To: Natural Resources Wales
From: Jen McMillan
Date: 25 February 2020
Copy: James Orme, Graham Morley
Our reference: PB5034-RHD-ZZ-XX-NT-Z-1000
Classification: Project related

Subject: Updated assessments for terrestrial ecology (excluding chough) in response to comments made on the Environmental Statement by NRW and RSPB: draft for discussion in meeting schedules 28/2/2020

We consider a *de minimis* impact argument can be made in relation to the impact of the designated features of the SAC, its extent and distribution, quality of vegetation and the structure and function of the SAC.

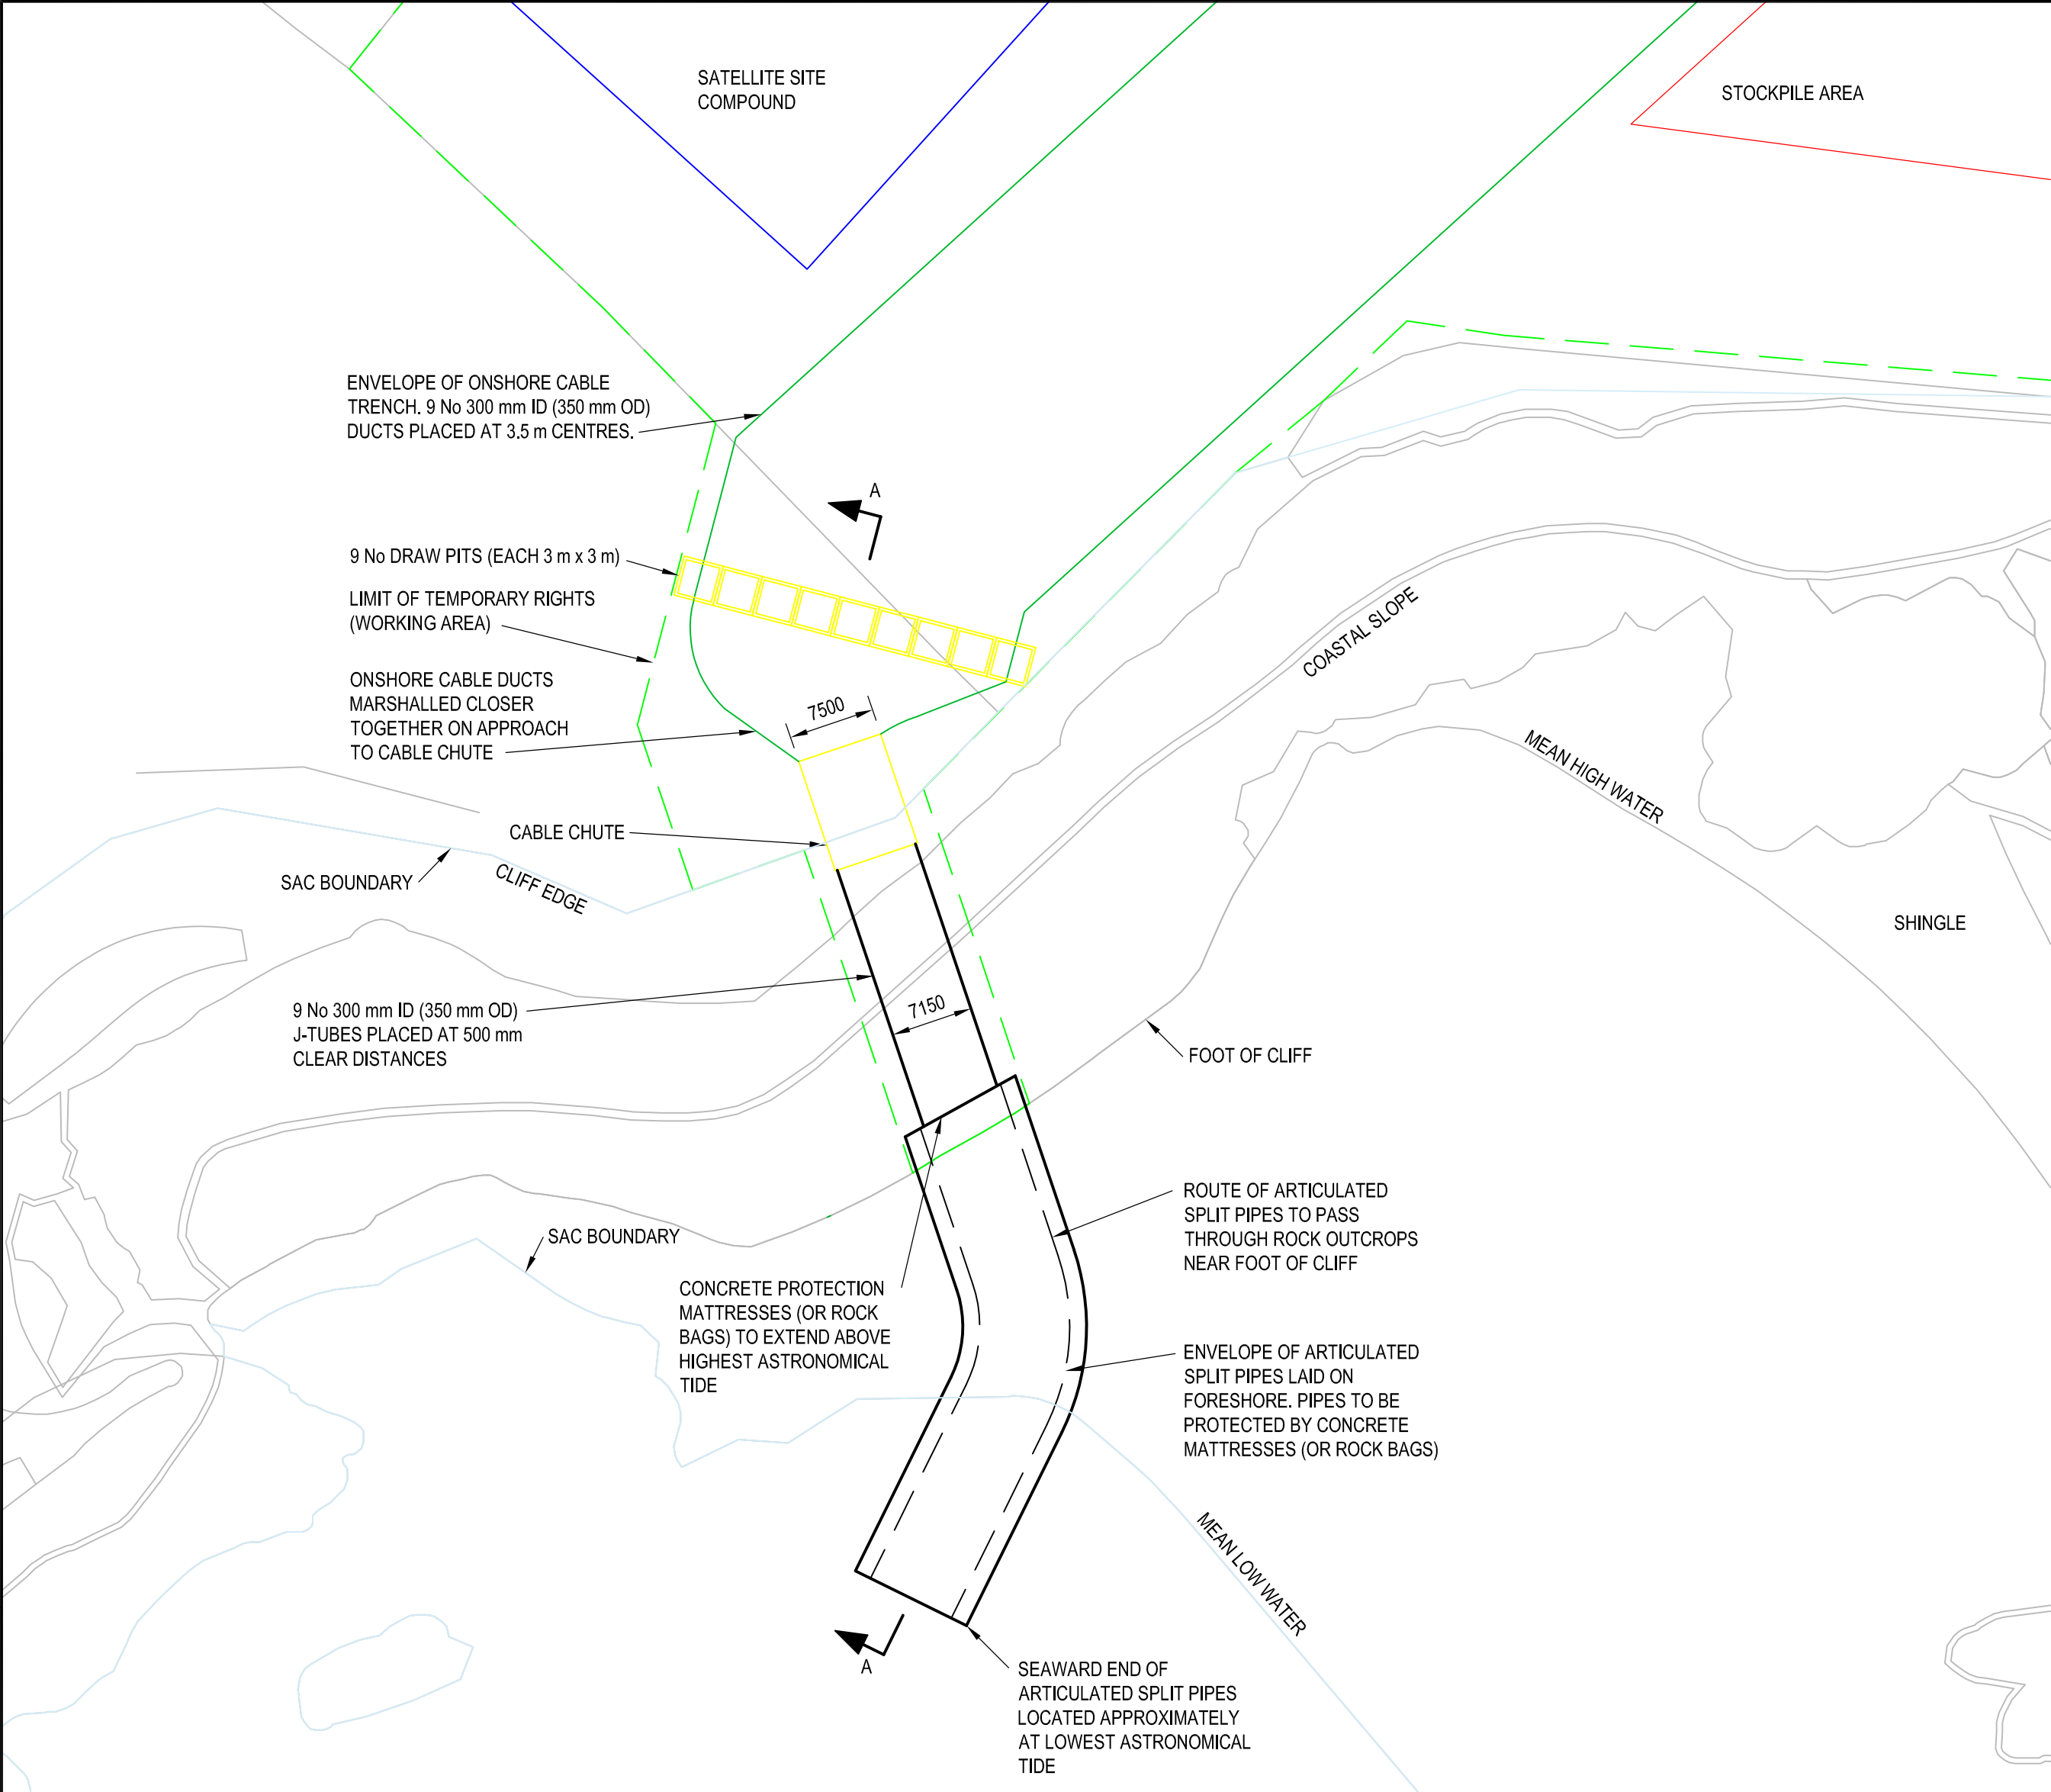
Comment Number	Comment Detail	Morlais Response
7	Paragraph 218 refers to cables being temporarily pinned to the cliff if HDD is not possible. However, if this is for the duration of the project, i.e. 37 years, NRW Advisory considers this to be a permanent impact (as defined in Table 5-5 of the ES, Volume I), rather than 'temporary'. The same paragraph refers to reinstatement of temporarily lost or disturbed habitat. If the same interpretation of 'temporary' is used reinstatement may not occur until after the end of the project, which NRW Advisory cannot agree with.	Assessment updated in Section 6 of this document and includes for permanent impacts
8	Paragraph 219: Considering that the trench is described as up to 10m wide with a 30m wide working corridor, turf storage would be expected to take up a 10m wide strip leaving just 10m of the 30m wide working corridor for vehicle movements and soil storage etc. NRW Advisory is therefore concerned as to whether the proposed turf reinstatement method would be workable. As a minimum there should be a temporary fence preventing vehicles driving on the edge of the stored turf. Turf would need watering in windy weather as well as dry.	Locations shown on Drawing 2 (Ref: 122938-BVL-Z0-00-DR-Z-00003) and methodology discussed in Section 5 Assessment updated in Section 6 of this document

Comment Number	Comment Detail	Morlais Response
	clarification on how shallow slots would be cut into the cliff and how this would be done without major permanent damage to the SAC feature.	
22	NRW Advisory disagrees with the conclusions regarding the impact on the Holy Island Coast SAC because calculations of the potential impact on the SAC are based on the percentage of the whole SAC area rather than the area covered by the designated feature i.e. vegetated sea cliff.	Assessment updated in Section 6 of this document including updating the percentages based on the feature
23	NRW Advisory disagrees that habitat loss associated with the worst-case open trenching method (if required) would be temporary; we consider that some at least will last for longer than the 37-year operational period and hence could be considered permanent (as defined in Table 5-5 of the ES, Volume I).	Assessment updated in Section 6 of this document including for permanent impacts

This section should be read alongside Drawing 1: 122938-BVL-Z0-00-DR-C-00600.P02-S2.

From the draw pits, the cable ducts will be marshalled closer together on approach to a structural steel cable chute positioned at the edge of the cliff. This length of cabling is anticipated to be installed using similar excavation equipment as per the main cable trenching works with the 32m working maintained to provide flexibility to complete the cliff side pinning works. Storage of turf (where practicable), top soil and excavated material will adopt the stockpile area used for the main trenching works which is in an area of Low Sensitive Habitat. The total excavated area of the cable trench between the draw pits and cable chute is c.191m² and will take approximately 1 week to complete (subject to production rates).

The thread bar anchors penetrate 3m into the rock, and will provide support the rock face of the cliff. Any maintenance of the J-tubes within the SAC is considered to be infrequent. In the unlikely event maintenance is required on the cliff face (i.e. within the SAC) the approach would be similar to construction, i.e. using a crane at the top of the cliff to support a lowered platform. As a worst case, the footprints and dimensions would be the same as per construction. It is likely that inspections of the J-Tubes would take place every 5 years and following severe storm events.
